# CITY PLAN COMMISSION STAFF REPORT

**CD-CPC-2026-00064**

## 11530 NW Prairie View Road Development Plan

**June 17, 2026**

## LIGHTING DETAILS:

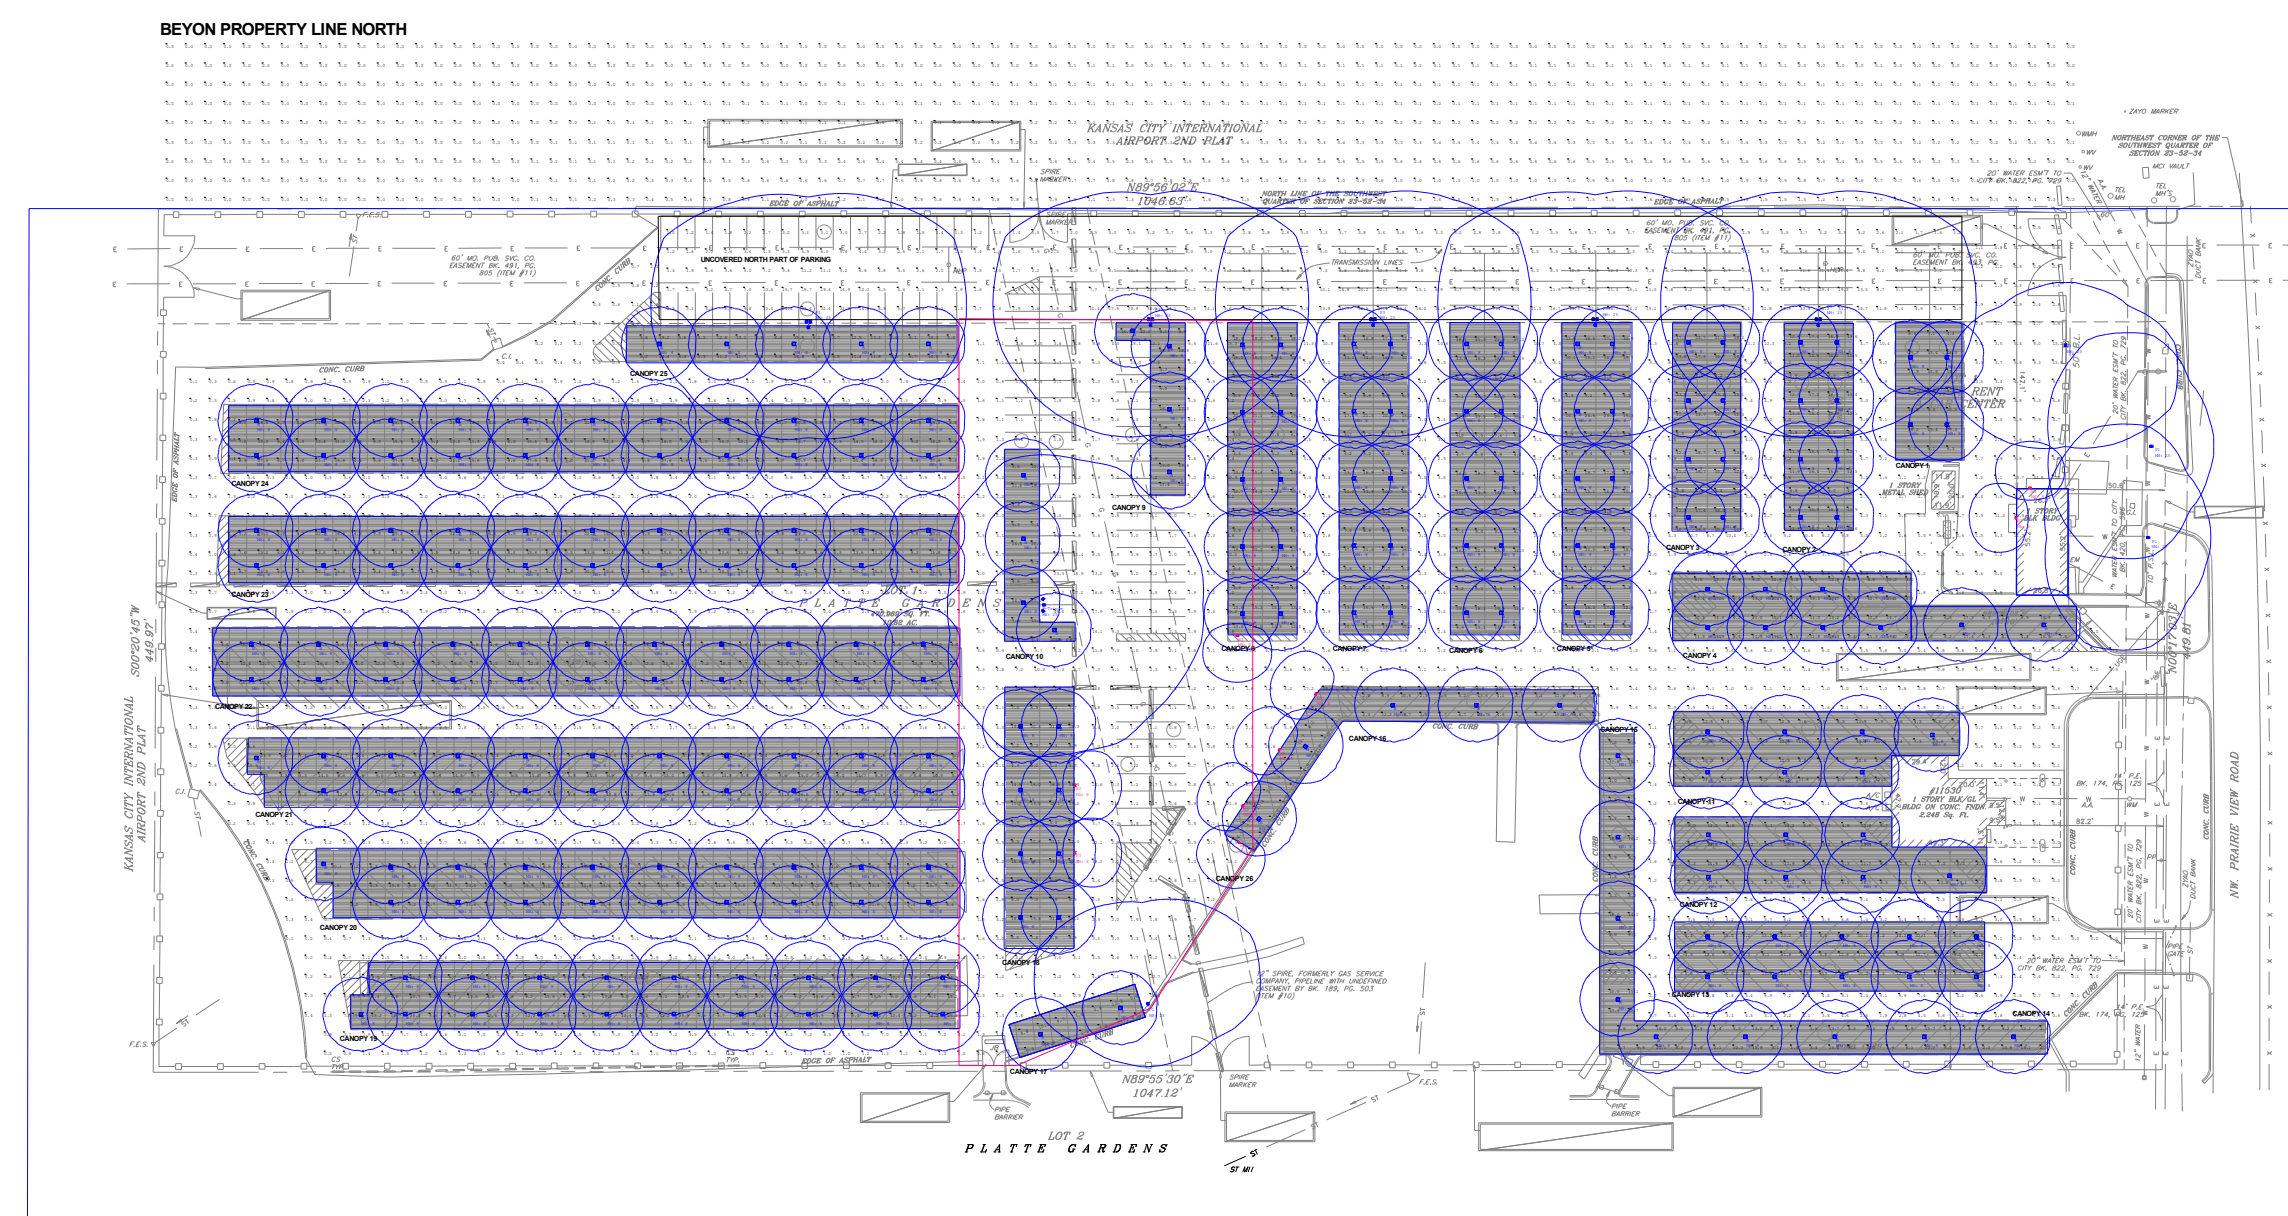
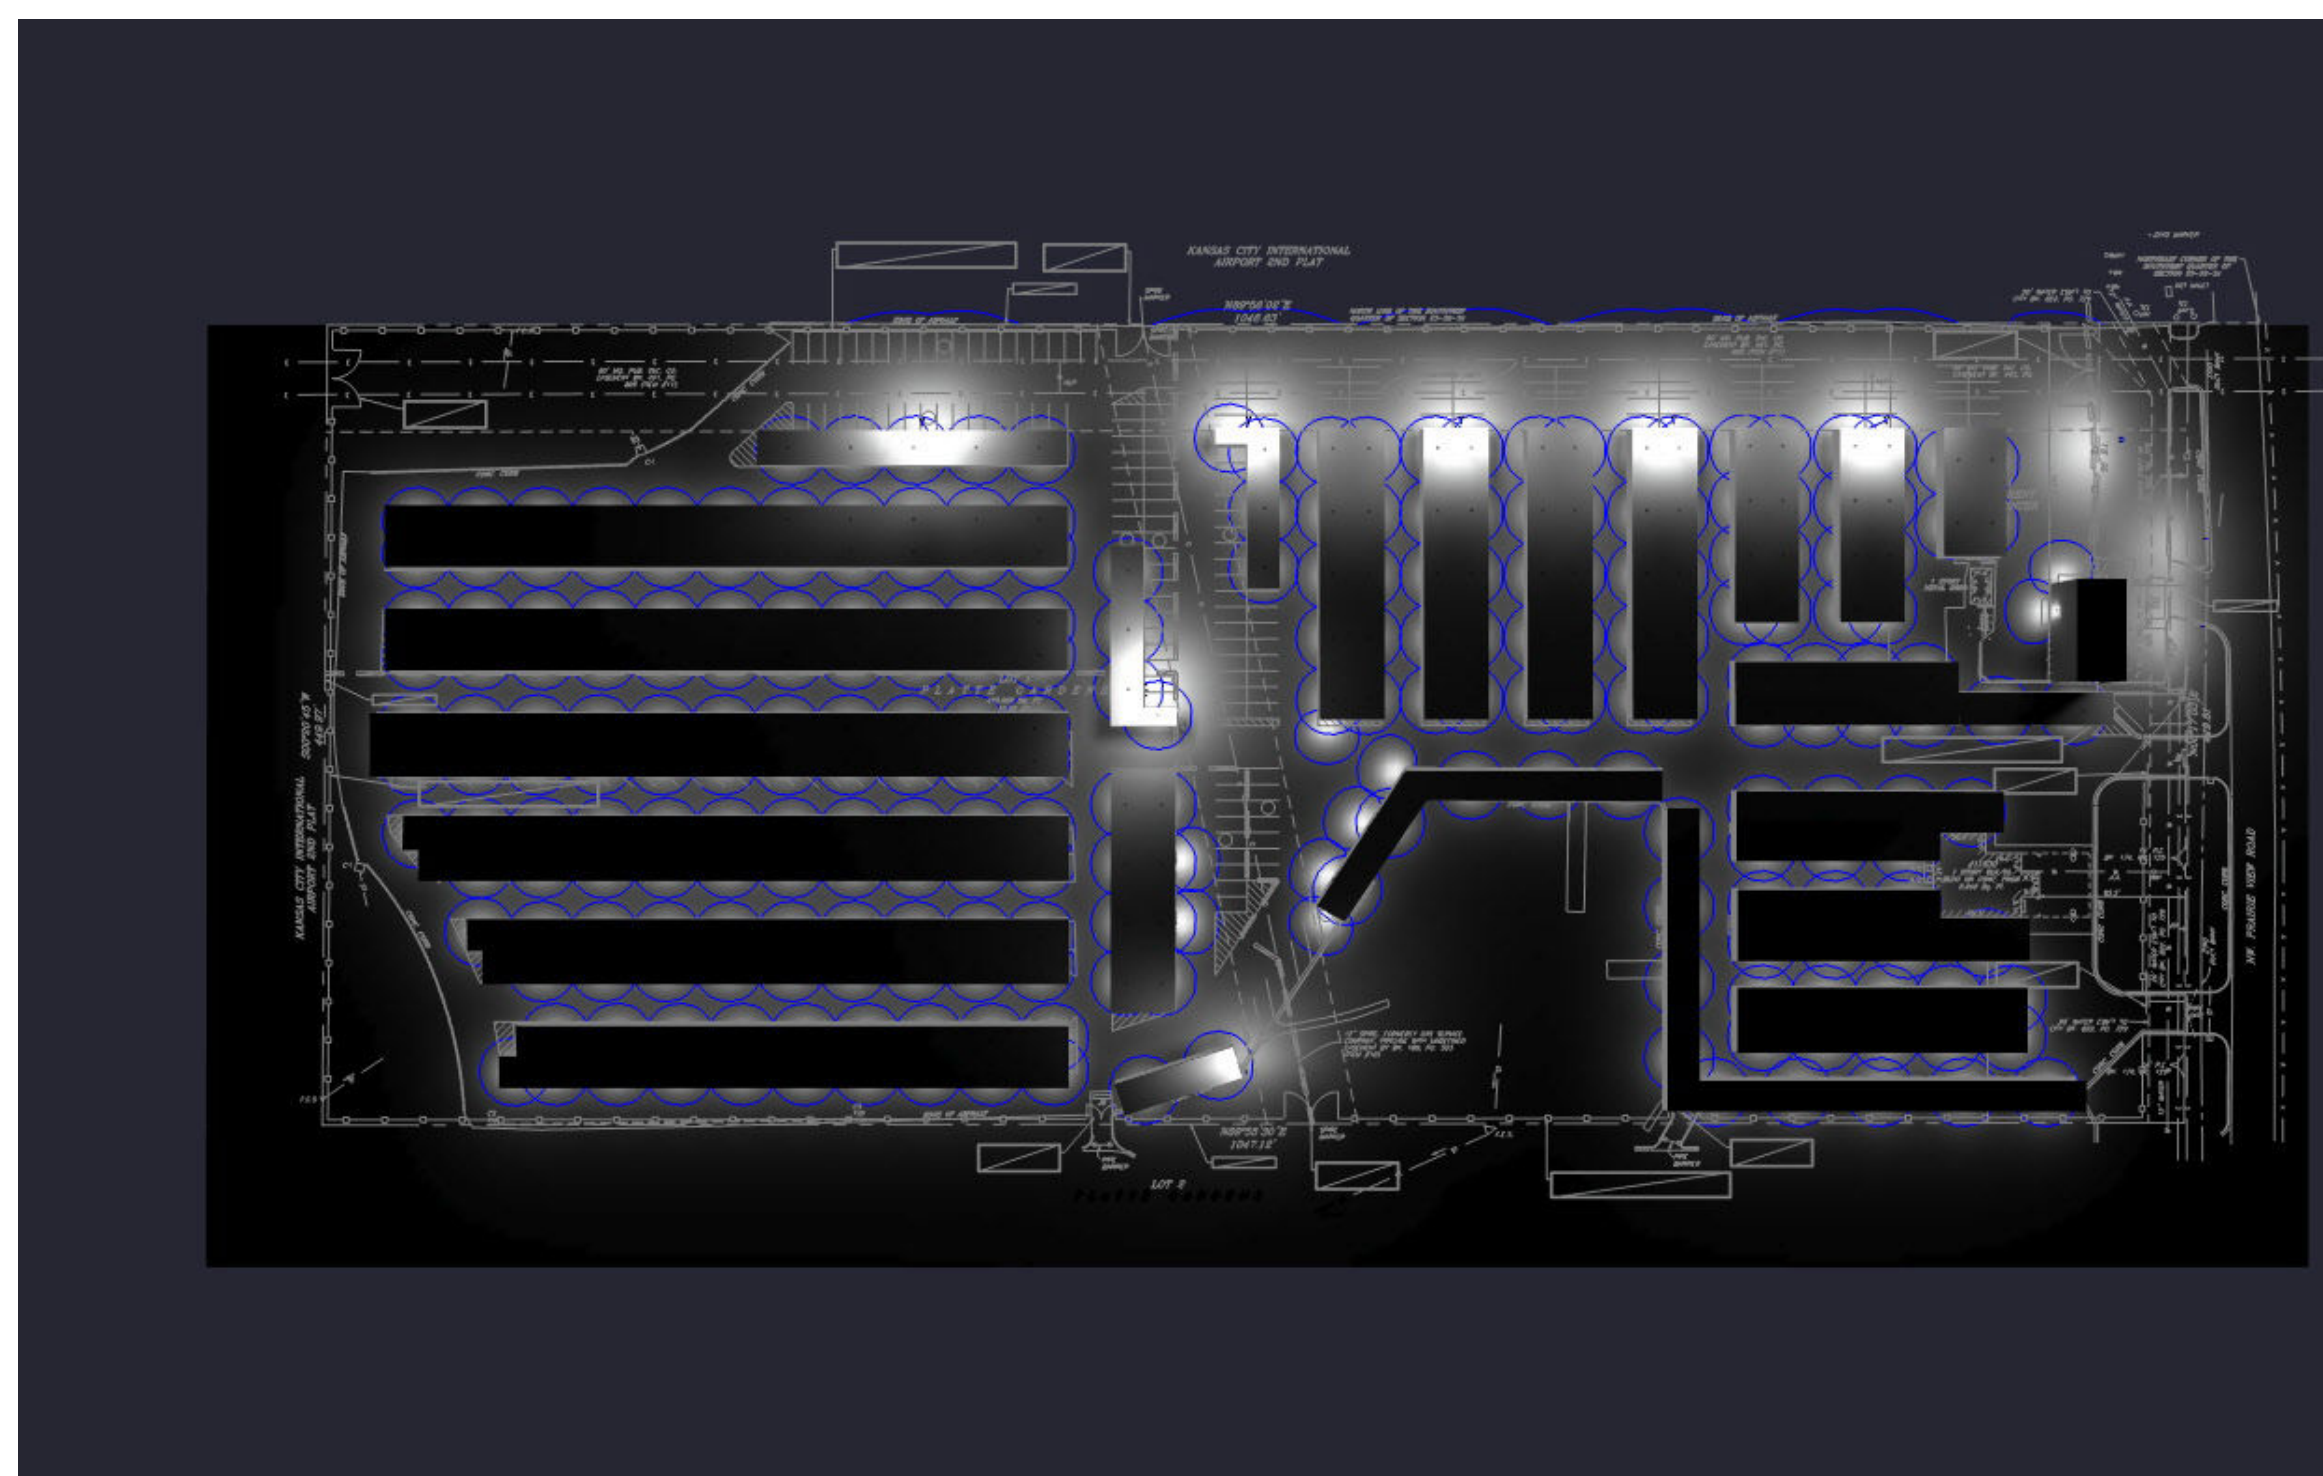
10. After discussion with property owner- prior to obtaining final plan approval, the lighting plan at a minimum shall show a lighting increase in the area between Canopy 8, 9, 10, 17, 18, 26 and near the east side vehicle entry/exit points where the lighting levels are 0fc-.10fc. Development Management Division reviewer may satisfy this condition.
